Greenbriar Development Project
Sacramento, California

Final Environmental Impact Report Responses to Comments and Additional Information

State Clearinghouse Number 2005062144

Figure 4-1: Comparison of Top of Levee and 1/200 AEP Water Surface Profile (with Levee Freeboard)

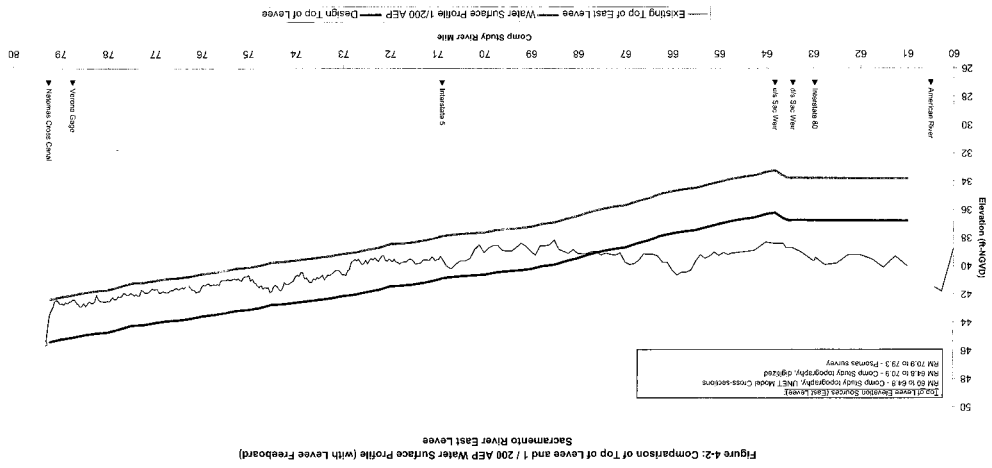
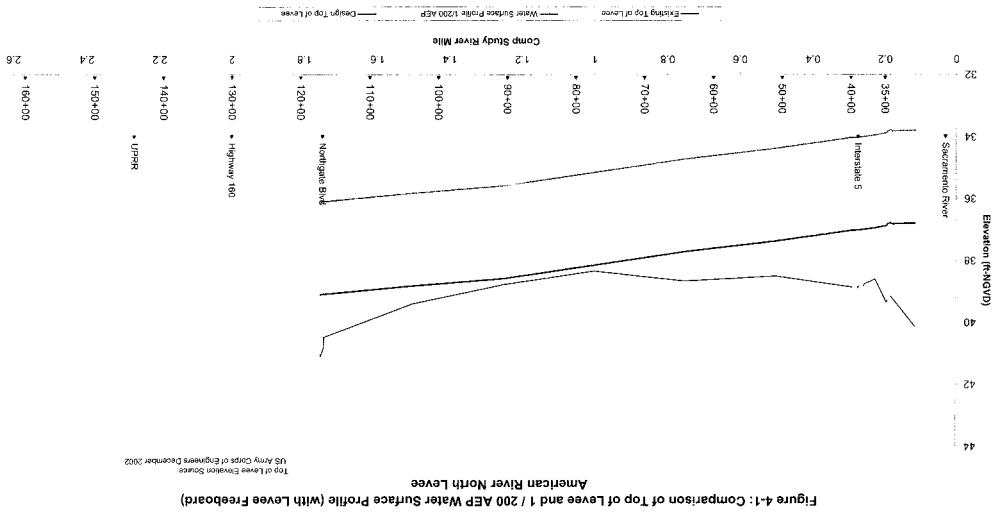
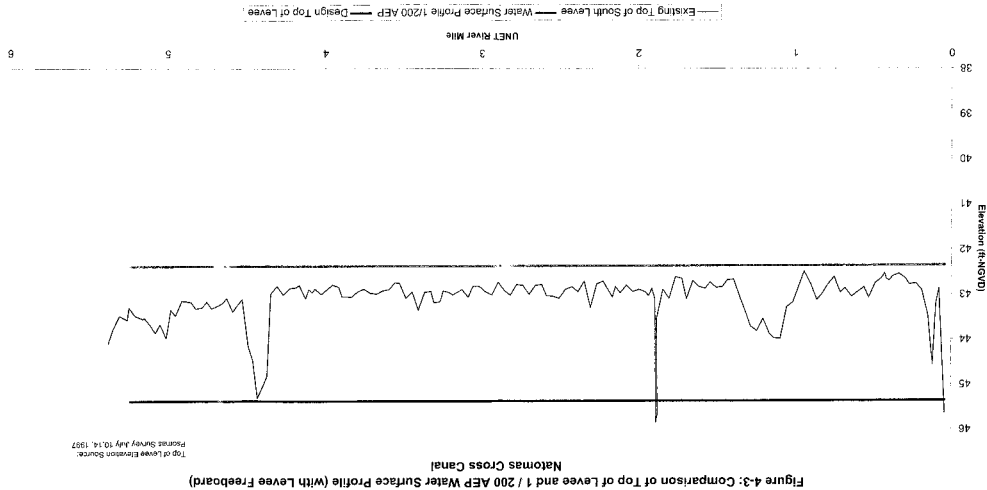
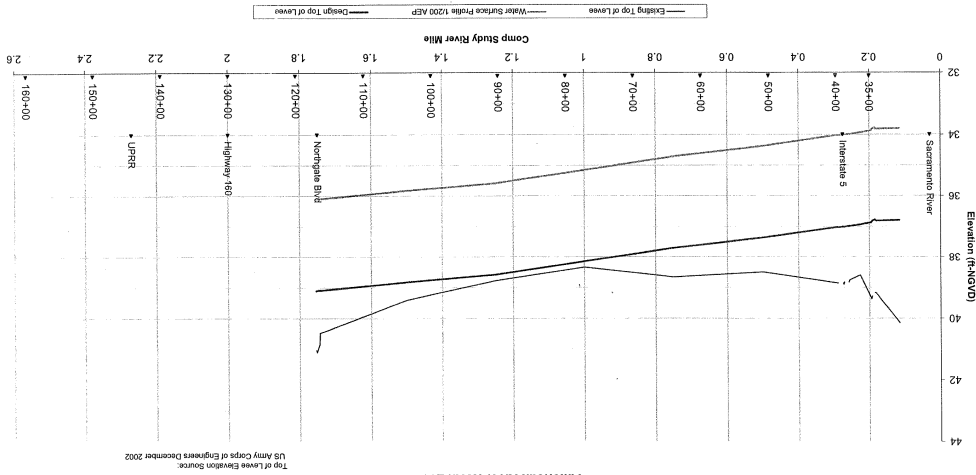
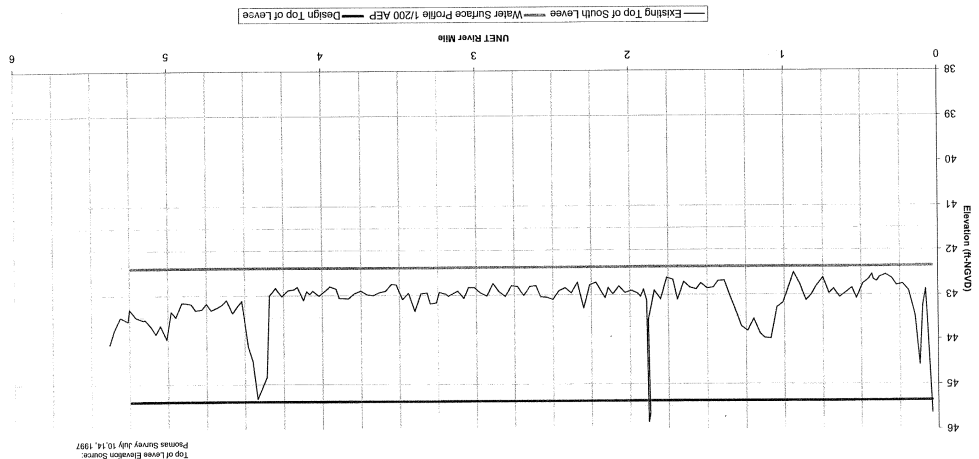
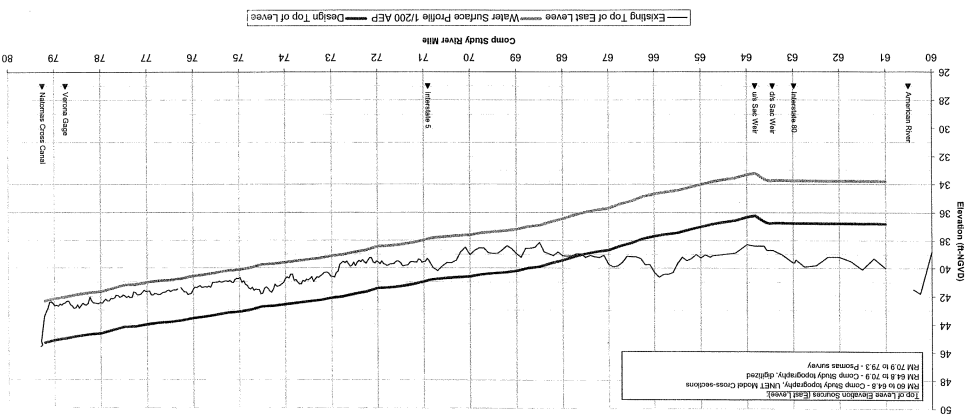
1. The Public Review Draft (Figures 4-2 and 4-3) contains a comparison of the existing top of levee, the 1/200 Annual Exceedance Probability (AEP) water surface profile, and the design top of levee to provide three feet of freeboard for the 1/200 AEP. These figures indicate approximately seventeen miles of proposed levee height increases up to three feet, not including the additional height allowance needed for wind and wave run-up. Figure 7-1 shows an increase in levee crown width of eight feet. Do the construction cost estimates include land acquisition costs to accommodate the increase in levee footprint?

Number	Comment	Response	Responder
HYD-1	The Public Review Draft (Figures 4-2 and 4-3) contains a comparison of the existing top of levee, the 1/200 Annual Exceedence Probability (AEP) water surface profile, and the design top of levee to provide three feet of freeboard for the 1/200 AEP. These figures indicate approximately seven miles of proposed levee height increases up to three feet, not including the additional height allowance needed for wind and wave run-up. Figure 7-1 shows an increase in levee crown width include land acquisition costs to accommodate the increase in levee footprint?	The construction costs estimates include an allowance for right of way acquisition.	SAFCA/PB
HYD-2	The Executive Summary of the Public Review Draft indicates that a key modeling assumption is made regarding the outflow from Folsom Dam, based on implementation of Variable Space Storage Operation and the Folsom Outlet Modifications Project. Given the uncertainty with implementation of the Outlet Modifications	The Natomas improvements are being planned as part of the American River Watershed Program as a way of ensuring compatibility of the various elements. The PASS II report indicates that the Folsom Dam Outlet Modification Project is feasible in the modified condition and will likely be	SAFCA/MBK

Figure 7-6 : Secondary Levee - Typical Section

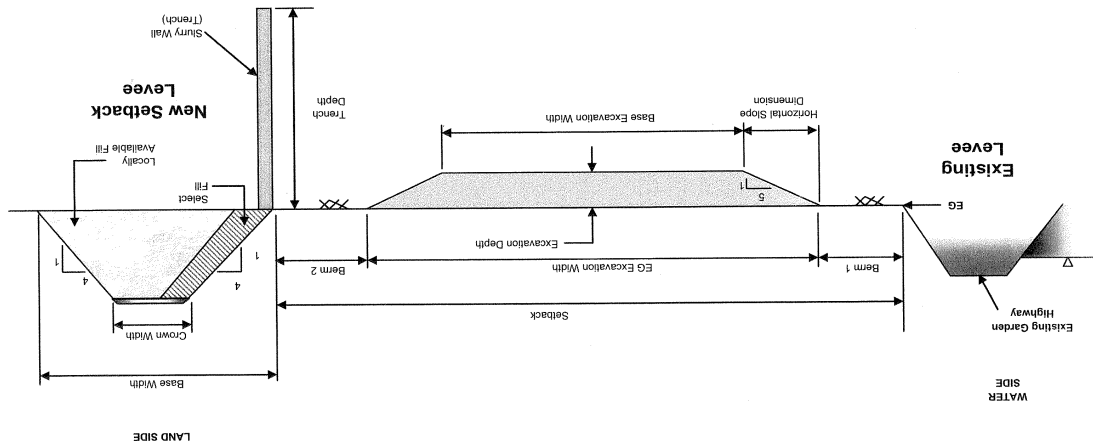
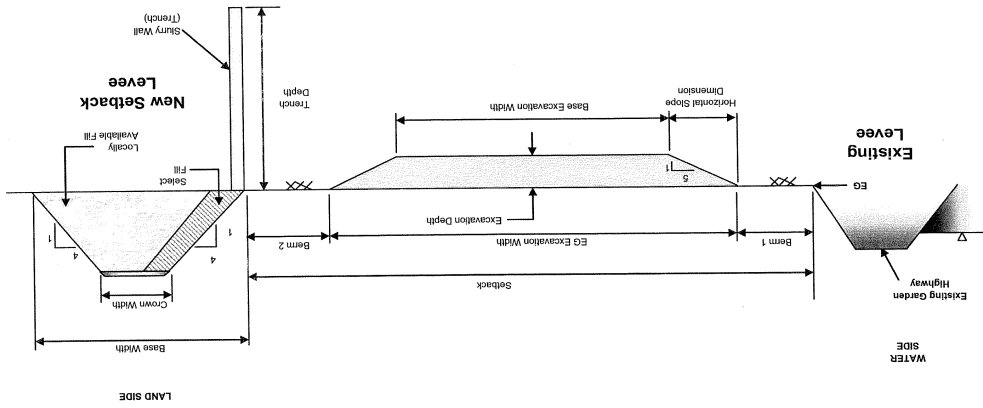
7. Section 2.3.5 Needs Improvements: Request a copy of the site prioritization list.
8. Section Figure 7-6 Secondary Levee - Typical Section. The Corps will not support the use of a borrow area between the existing and new levee. Additionally, erosion protection should be provided on the new levee.

Location of Greenbriar Project in Natomas Basin

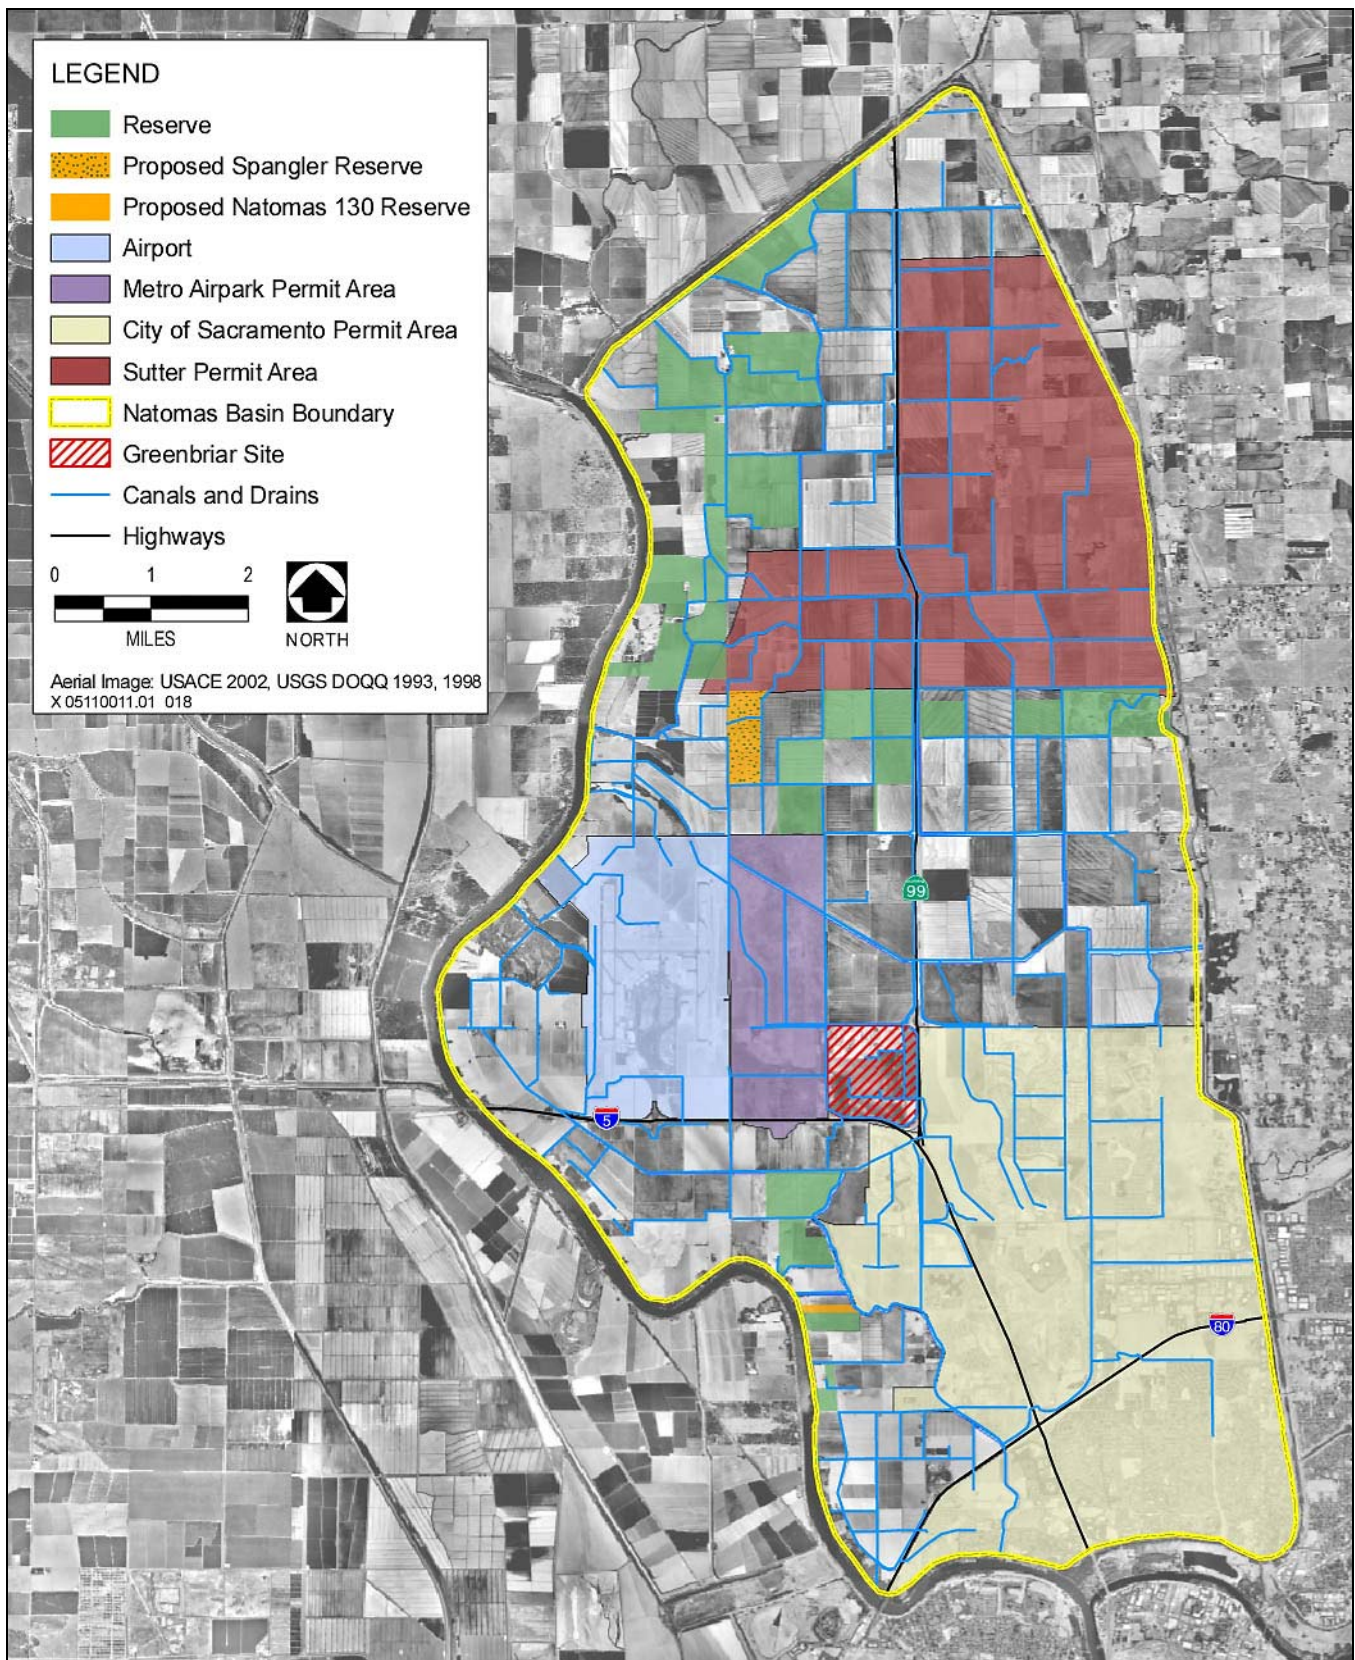
- D. **Depiction of Airport.** The Greenbriar Location Map (Exhibit 6.12, page 6.12-11) does not accurately portray airport lands. It essentially only shows the rough outline of the AOA, which could lead the reader to conclude that the County-owned land north and south of the Airport is available for non-airport related development, including future habitat mitigation by private parties. This exhibit should be revised to show existing land owned and maintained by the County for land use compatibility purposes. The area designated “Airport” on Exhibit 6.12 should include all parcels owned by the County, including those located in Sutter County south of Riego Road. See attached Airport property map exhibit. 21-19

- 21-18** Please refer to response to comment 19-6, as well as response to comments 21-14 and 21-17.
- 21-19** Although the boundaries of the Sacramento International Airport may not accurately portray all airport controlled lands in Exhibit 6.12-4 of the DEIR, the purpose of the exhibit is to depict the locations of existing biological habitat reserves that have been established by the NBHCP. Changing the exhibit to show all parcels owned by the County would not change the overall depiction of the exhibit and does not affect the analysis of biological resource impacts conducted in the DEIR. However, Exhibit 6.12-4 has been revised to incorporate the commenter's requested changes. The revised exhibit is presented in Chapter 7, "Revisions to the DEIR, RDEIR, and Second RDEIR."

Exhibit 6.12-4 is hereby revised as follows (see comment 21-19):

Exhibit 7-1 is hereby revised as follows:

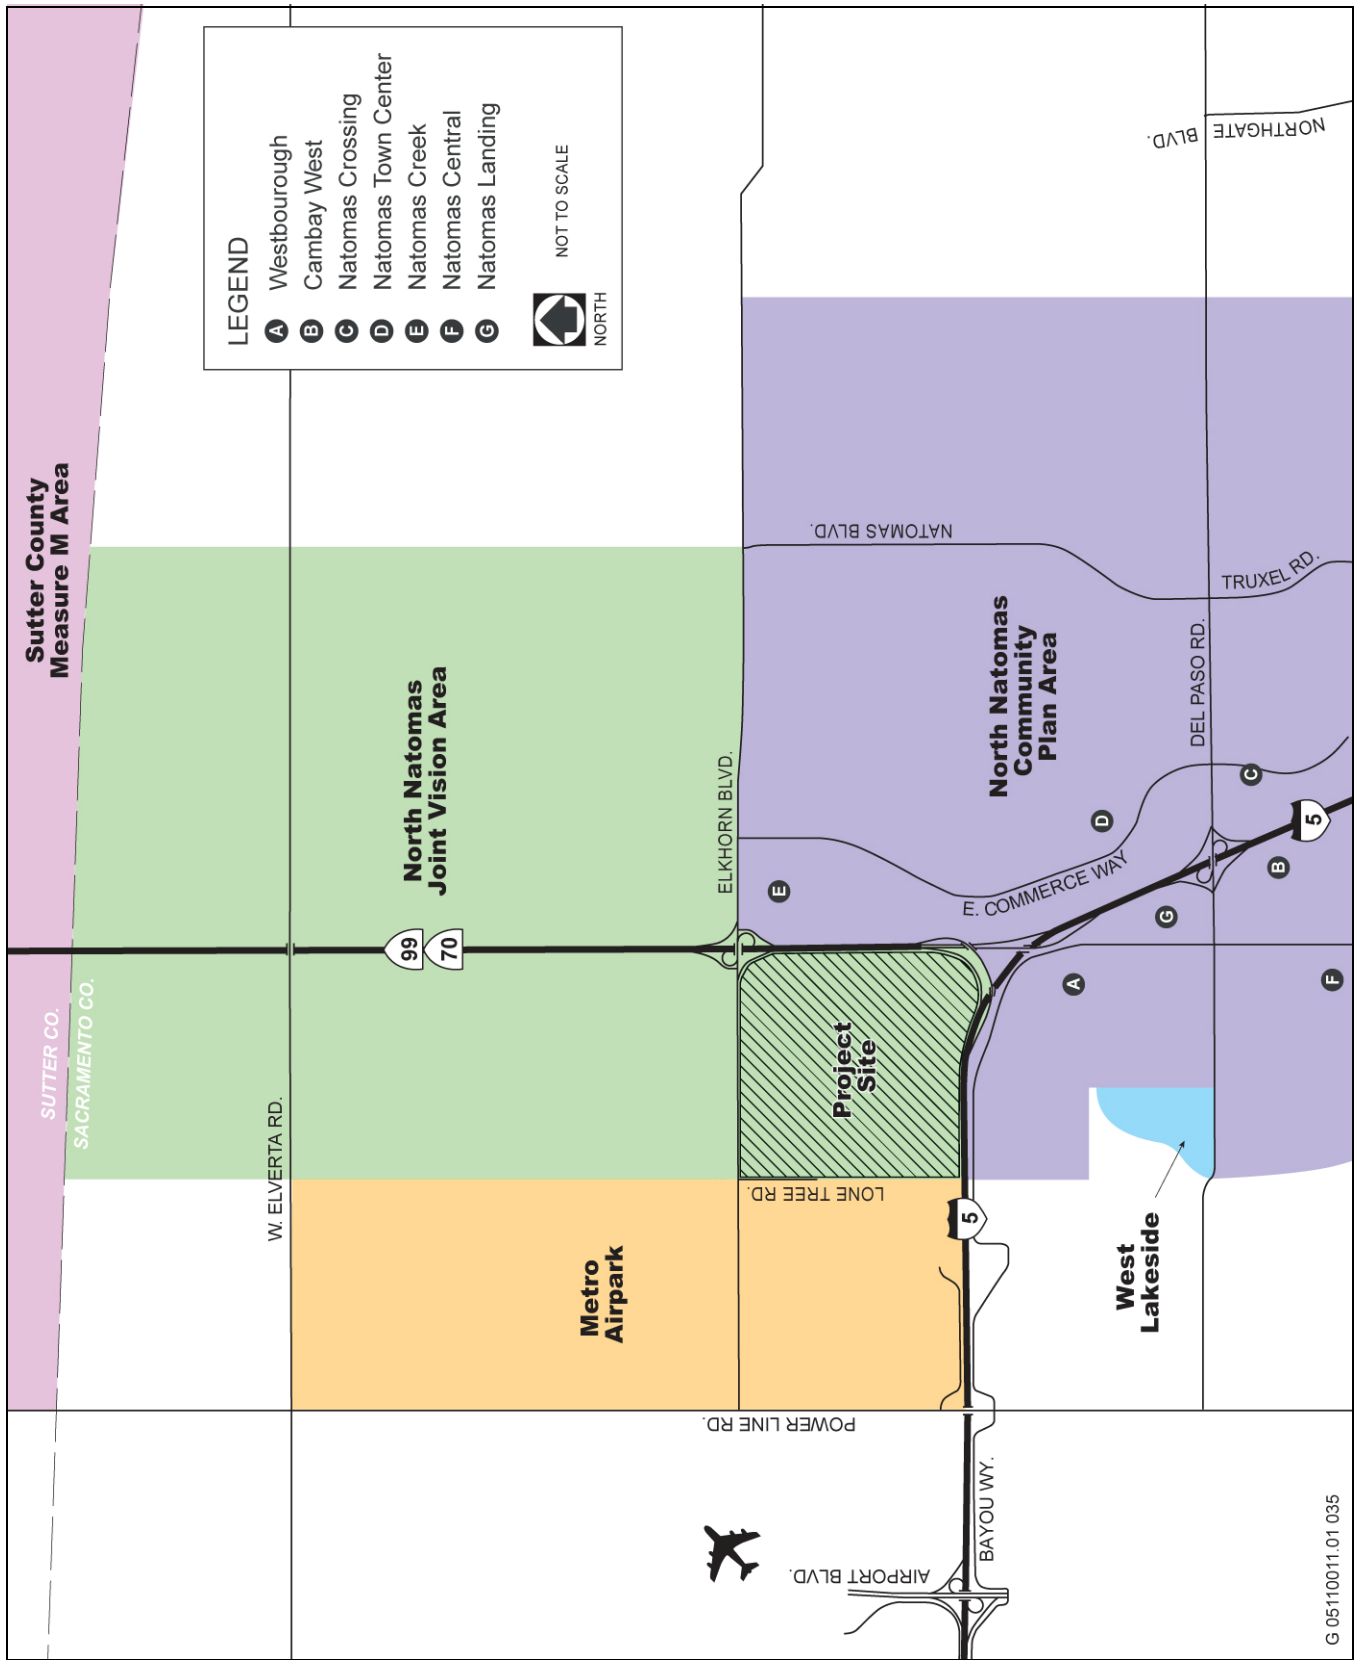
Exhibit 7-1 does not show the correct boundaries of the NNCP Area and excludes the Bayou Way Properties.

35-13 Exhibit 7-1 has been revised to reflect the correct boundaries of the NNCP. Please refer to Chapter 7, “Revisions to the DEIR, RDEIR, Second RDEIR,” of this document.
